**BC Timber Sales  
Kamloops Business Area  
Cascades Field Team  
Gotchen-Bosk Visual Assessment  
by RDI Resource Design Inc  
March, 2016**

**Go15 - RDI component**

Go15 RDI Option 1-2-4-7 from Bosk Lake Viewpoint 1 - 5.87% Alteration - Meets Partial Retention

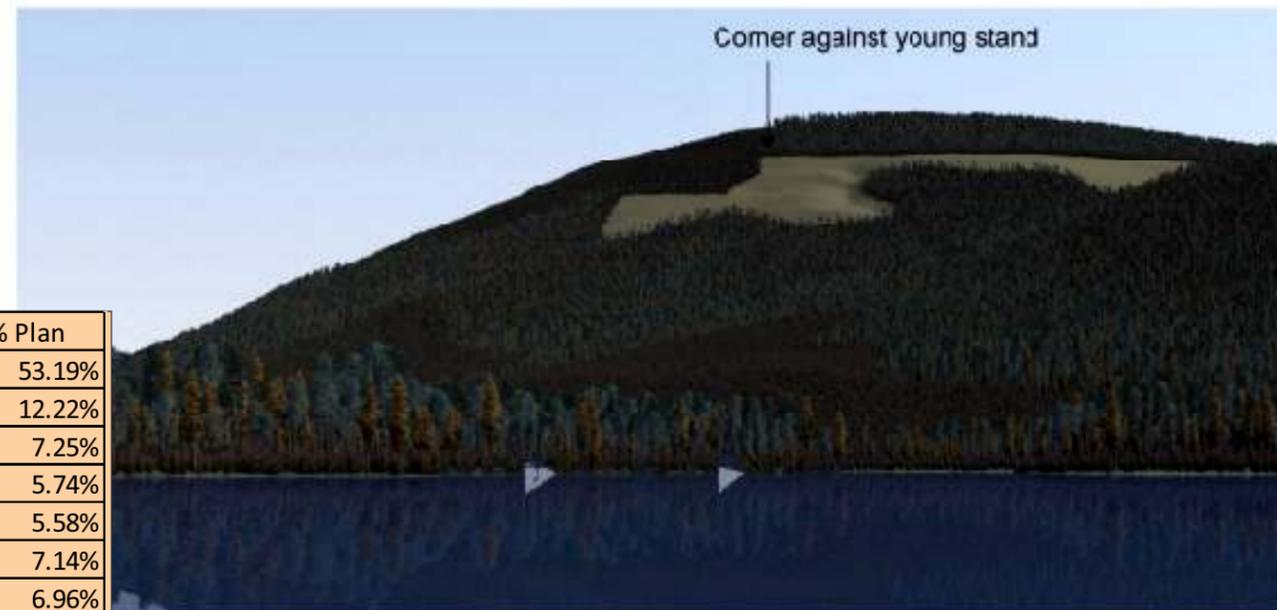
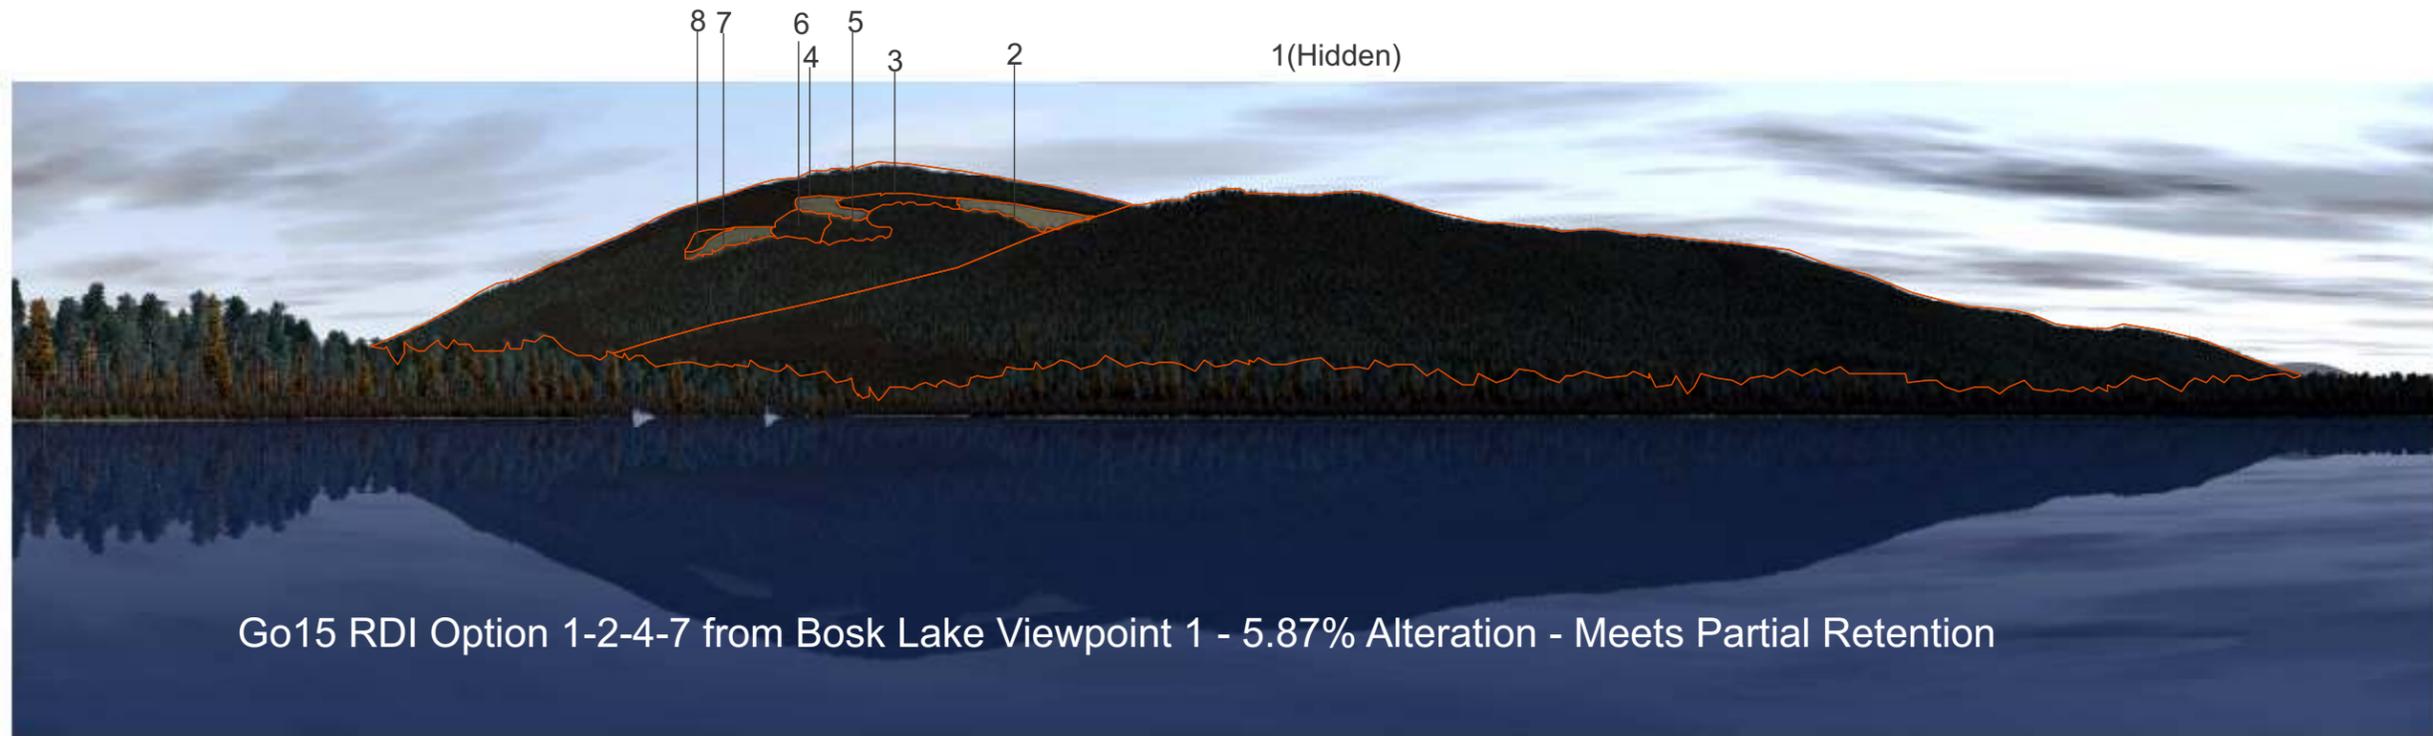
If No why? \*This has been asterisked as this VIA assessed both the original plan which fails to meet the VQO and a scenario by RDI which meets the VQO. The original design would lay broadly horizontally across the landform, cutting the dominant visual forces. By appropriate selection of leave patches suggested by RDI, the visual forces will be maintained while bringing the block into shape and scale meeting the VQO.

Go15 Preliminary Configuration from Bosk Lake Viewpoint 1 - 12.6% Alteration in Perspective View - Exceeds Partial Retention - Meets Modification

Go15 Preliminary Configuration from Bosk Lake Viewpoint 1

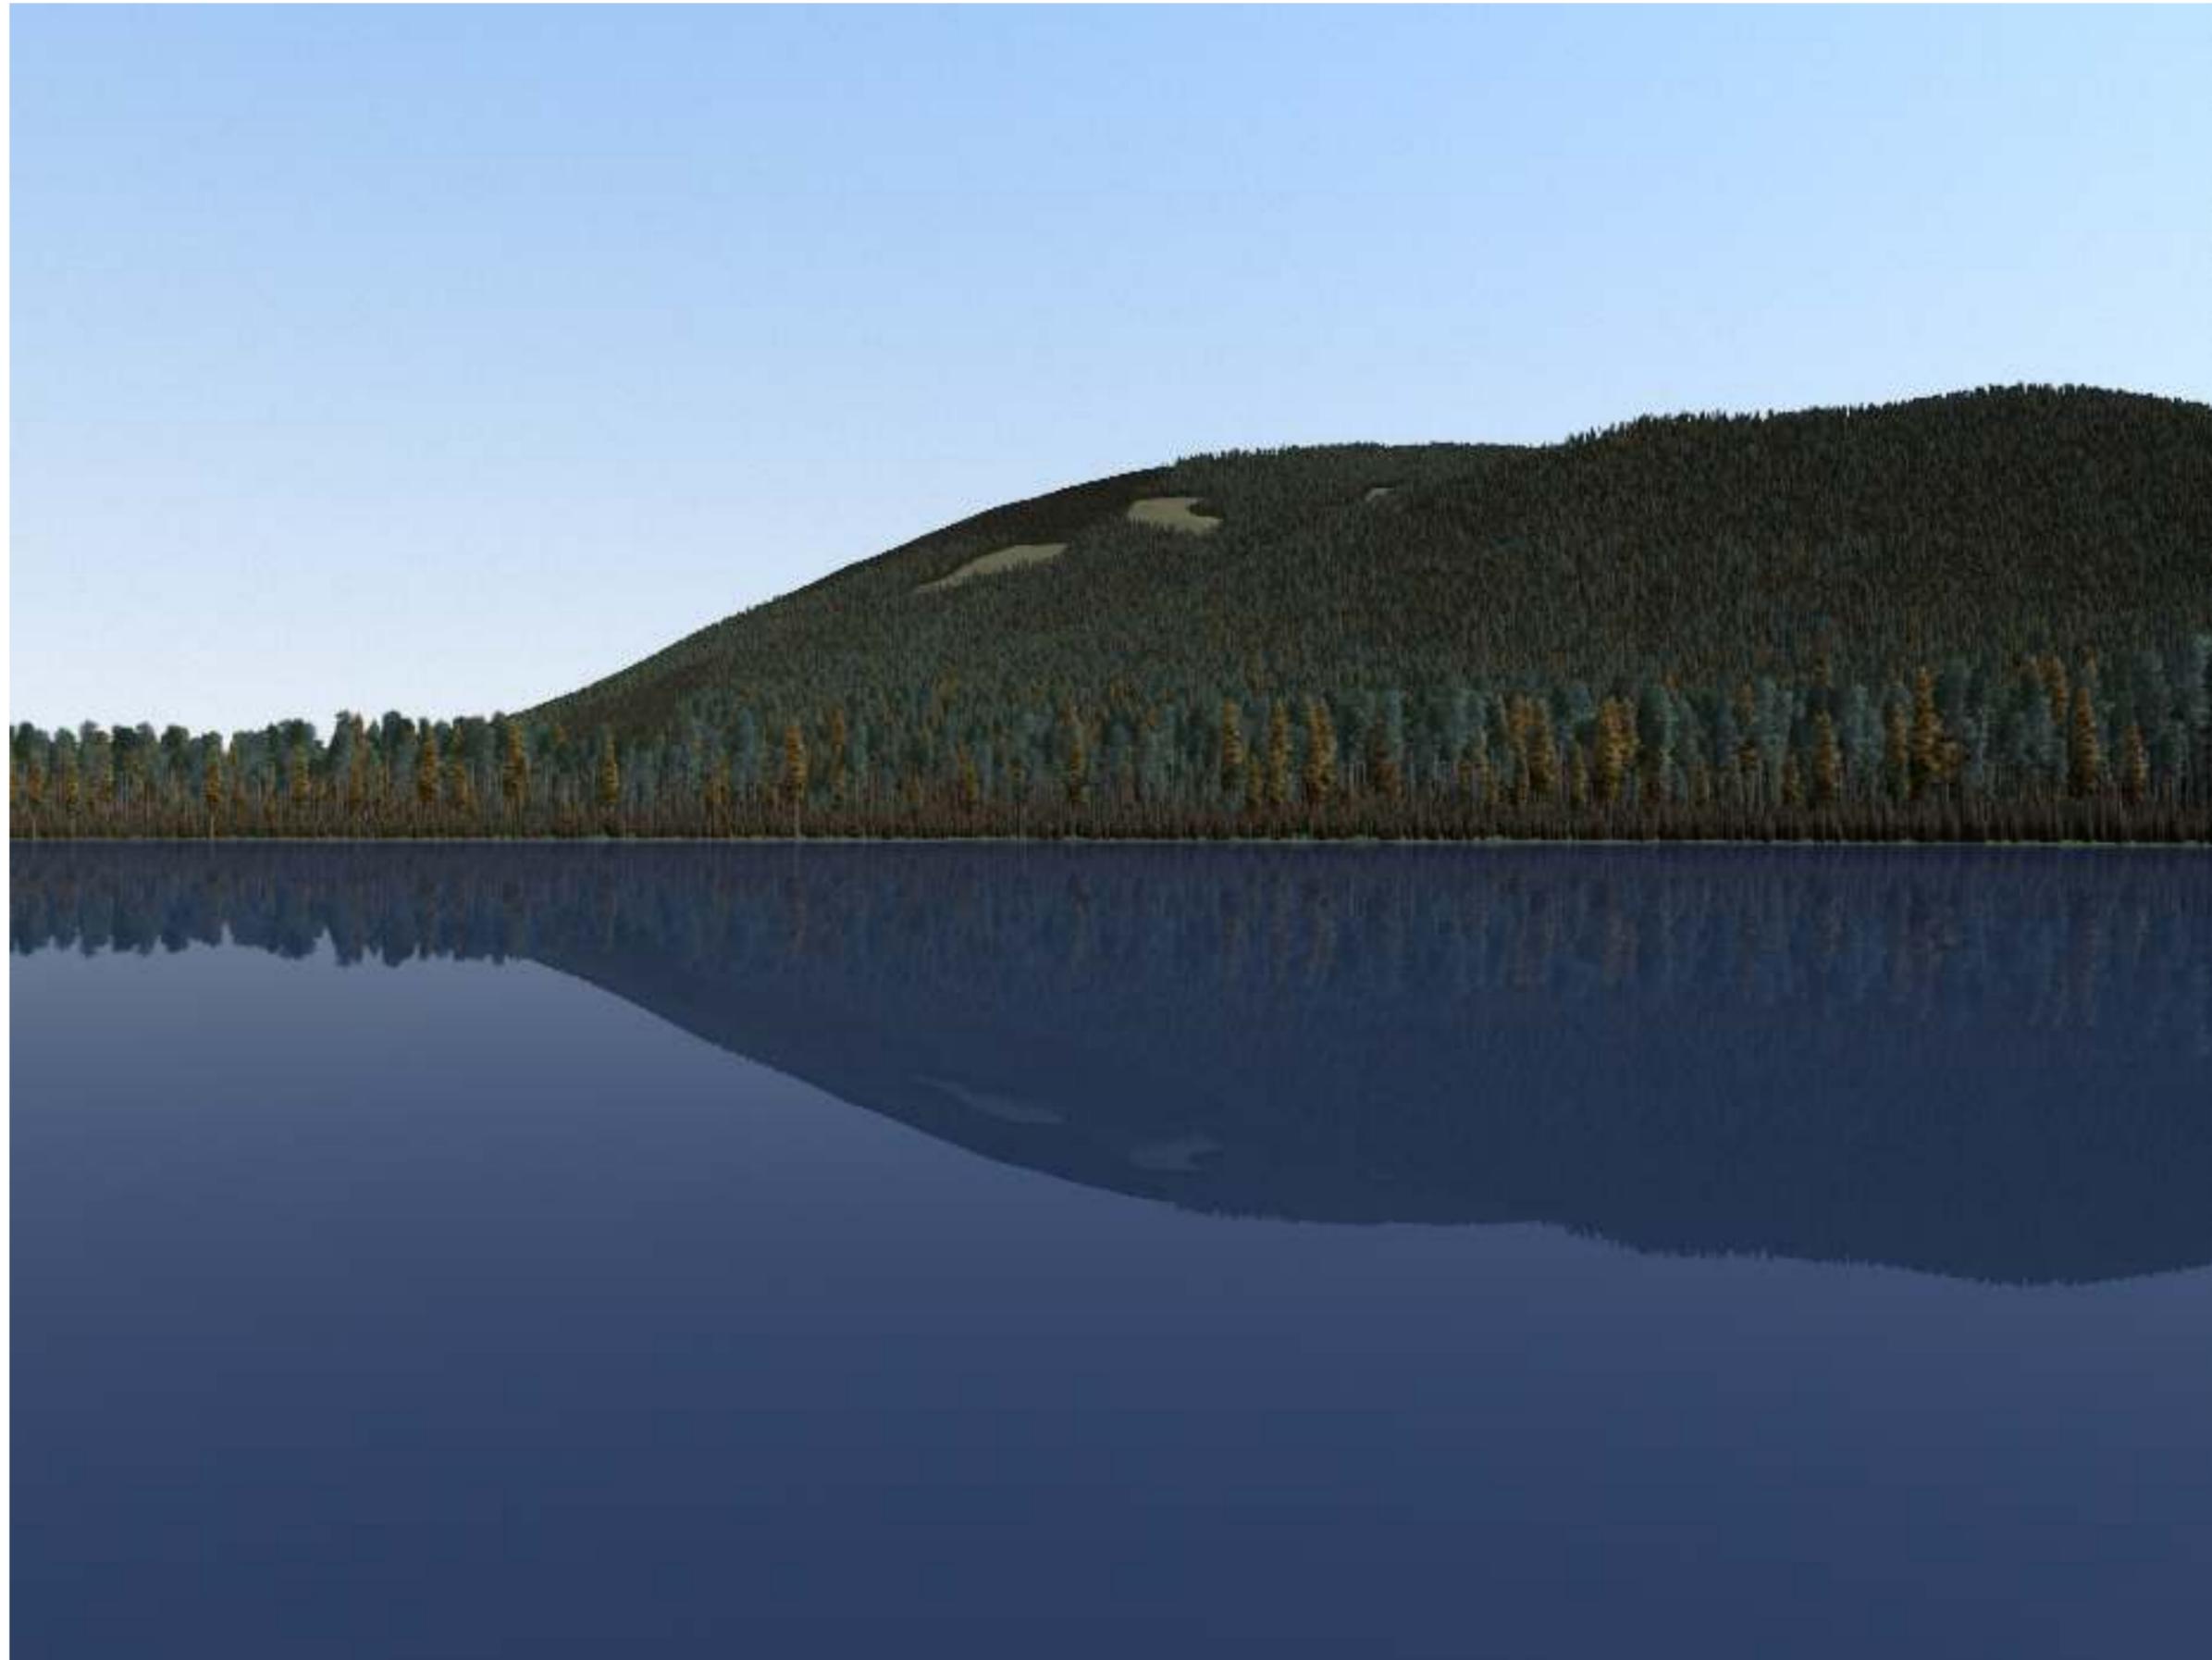
Go15 Preliminary Configuration from Bosk Lake Viewpoint 1 - 12.6% Alteration in Perspective View - Meets Modification  
 RDI Option 1-2-4-7 - 5.9% - Meets Partial Retention
